# Jacobsen Information Bulletin

**Bulletin No: C-013-04**

## **Kawasaki FH680V Oil Leak**

### #1 Cylinder Head Oil Leak (FH 601D, 641D, 680D, 721D) (FH 601V, 641V, 680V, 721V)

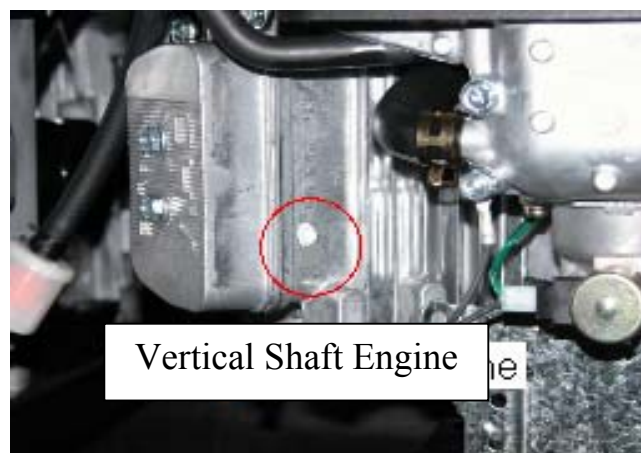
Oil leaks from the #1 cylinder head (Right side if viewing the engine from the back) near the oil return hole. This was caused by a defect in the casting die.

Kawasaki corrected the casting die and reworked engines in inventory. Kawasaki has also initiated a Factory Directed Modification (FDM) campaign to repair eligible field units. Each machine manufacture will notify end users of this campaign and direct them to an authorized dealer for repair.

### Repair Eligible Cylinder heads:

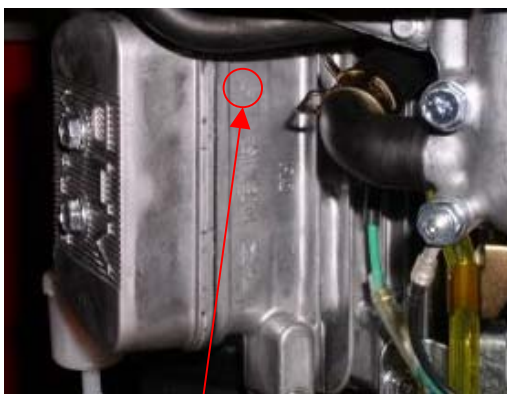
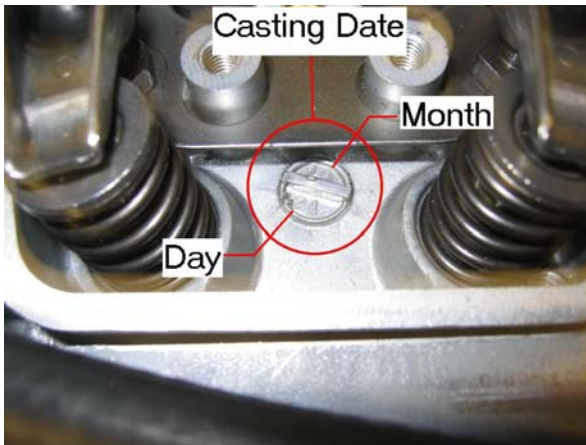
Engines in listed serial number range may have heads produced with defective casting die. (Cylinder heads produced between 7/31 and 10/21 with "K-3" die are suspect.)

Engines having a white dot painted on the cylinder head have been reworked before shipping to dealers and are not eligible for this repair even if they are in the above range.

- Determine if engine is within the suspect serial number range.
  - Check if cylinder head is a "**K-3**" casting die. (No problem on K-1, K-2)
  - Check if there is a white dot painted on the cylinder head. If there is no dot, Kawasaki has not reworked the engine.
  - Remove #1 rocker arm cover to inspect casting date.
- If the casting date is in the suspect range (7/31 to 10/21), replace cylinder heads.
